TRANSMITTAL

PROJECT : MMCEASTTOWER
CUST. NO. : 310

VIA : CUSTOMER WEB SITE
FOR : APPROVAL

Submittal No. 051200-0005-0

ELEVATOR HOISTWAY DEMOLITION PLAN @ LEVEL-5

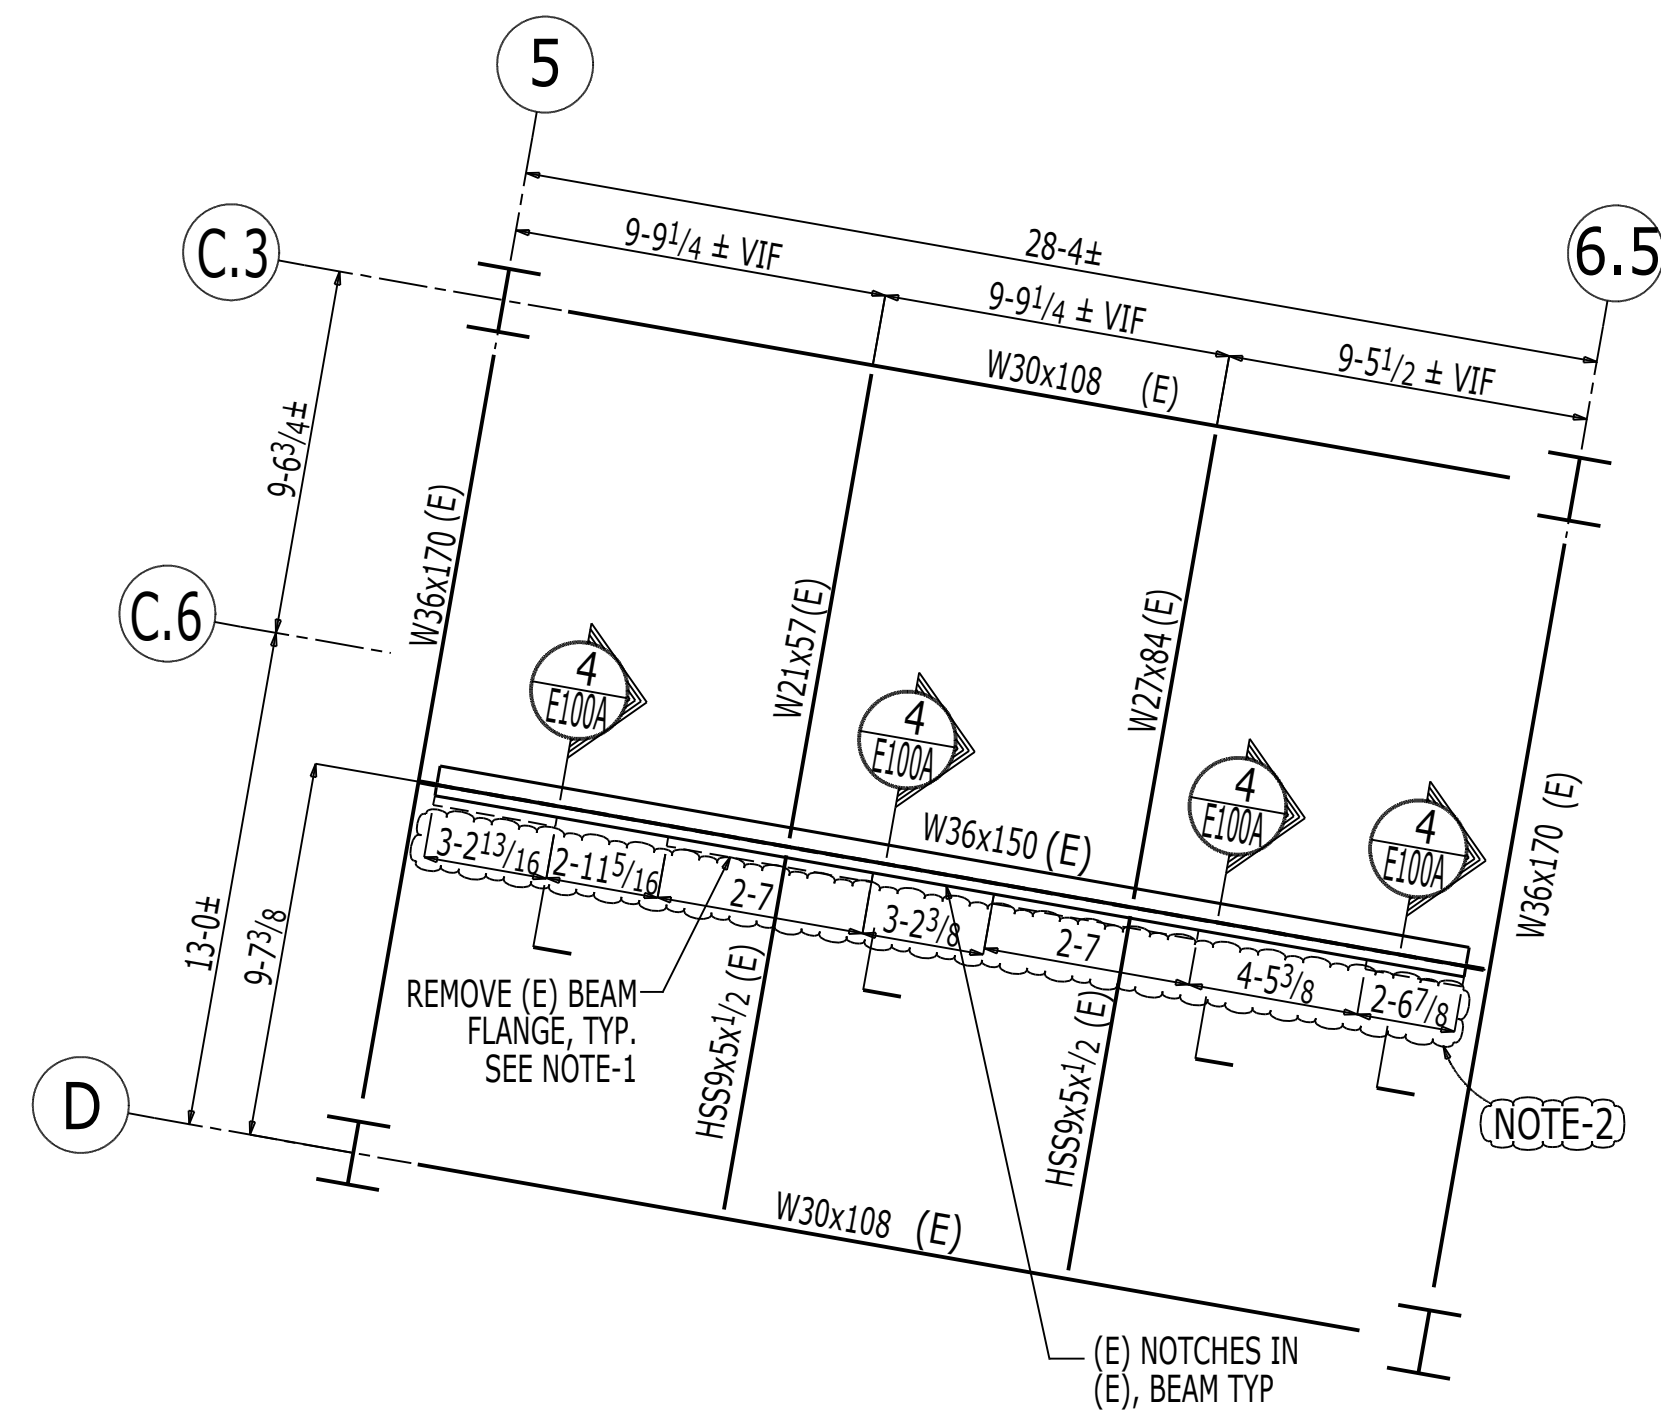
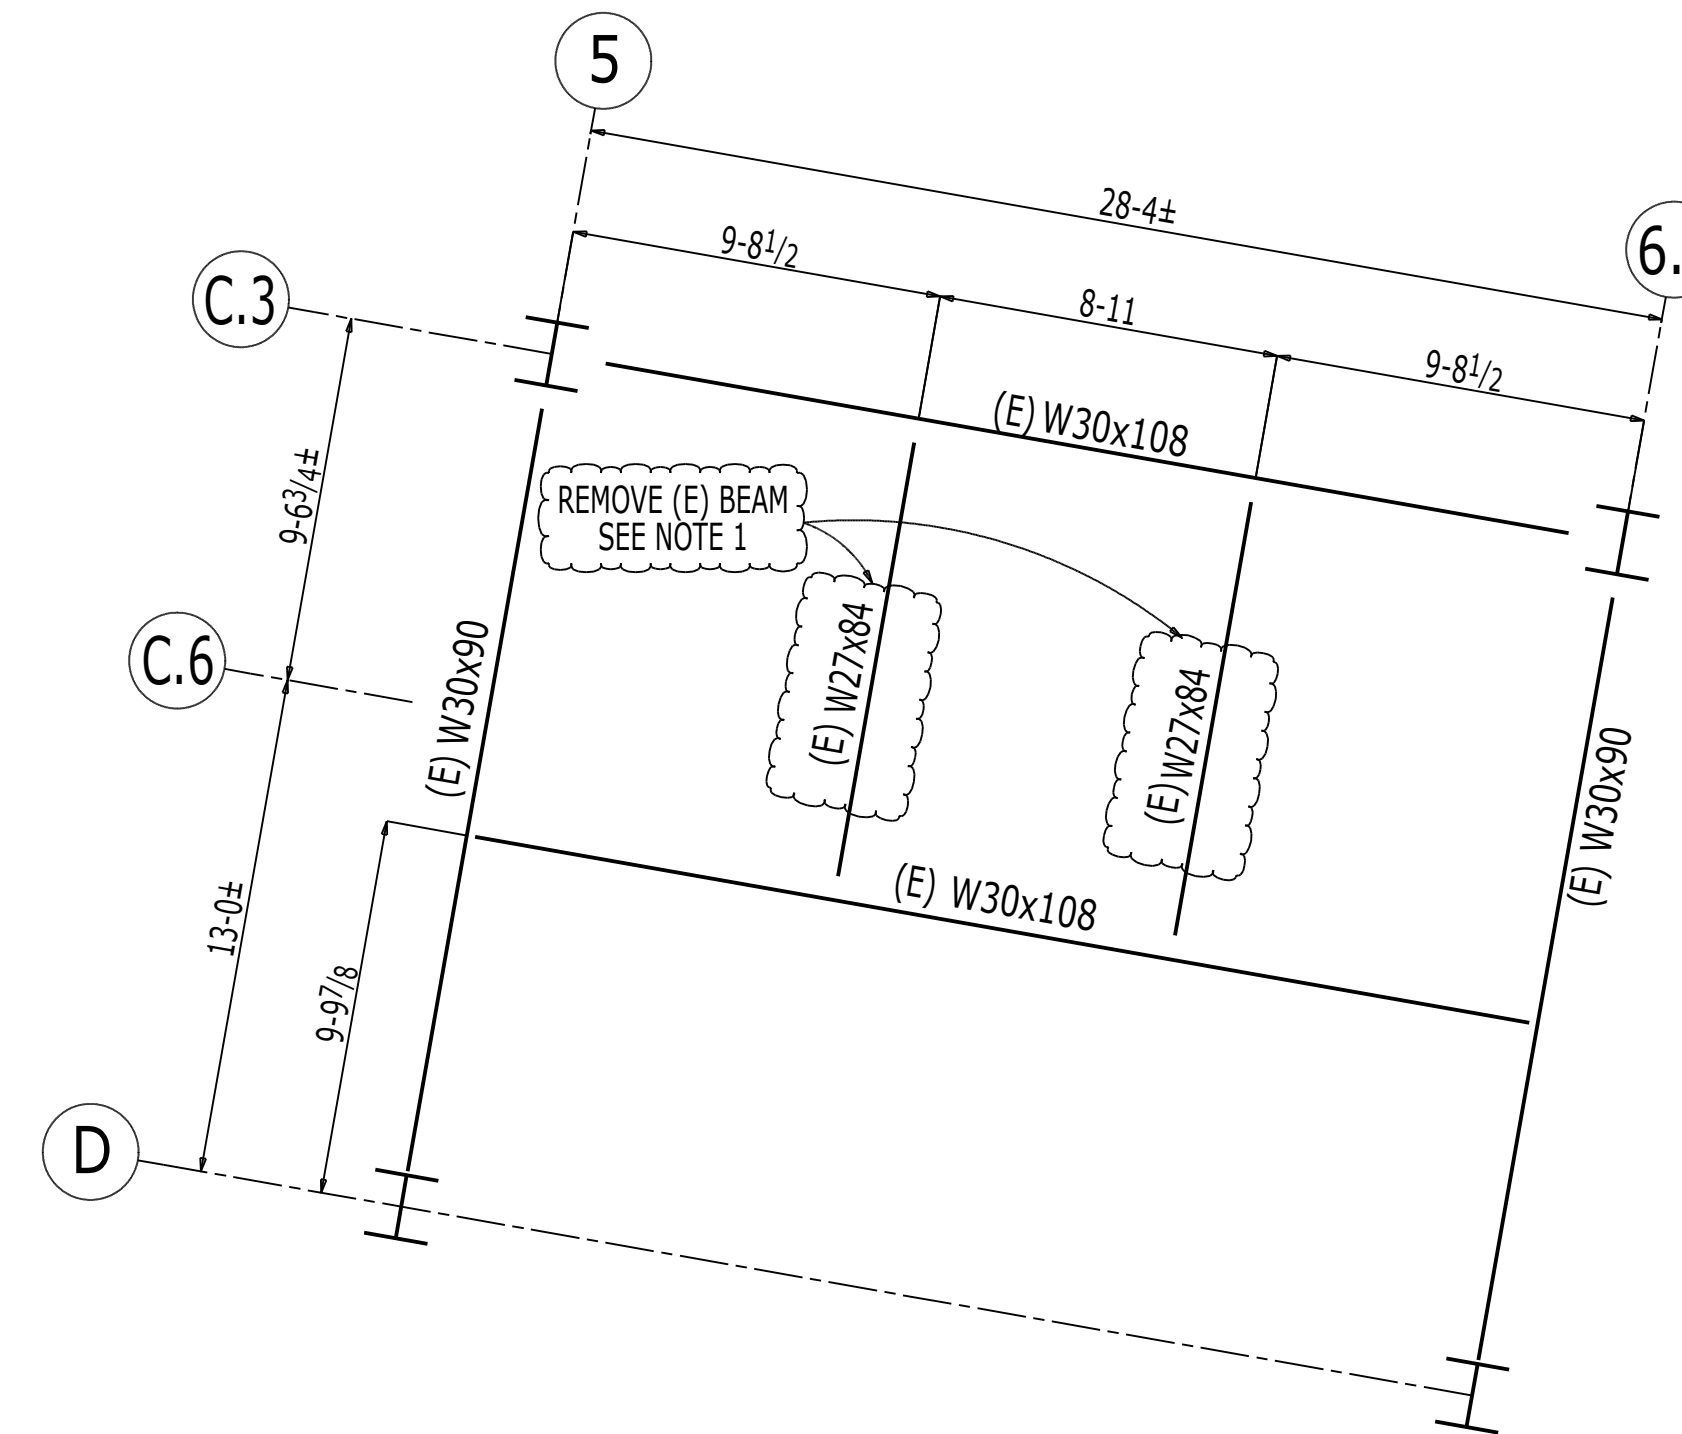
ALL ELEVATOR STEEL SHALL BE COORDINATED WITH ELEVATOR SUBMITTALS PRIOR TO FORMAL APPROVAL - RJM
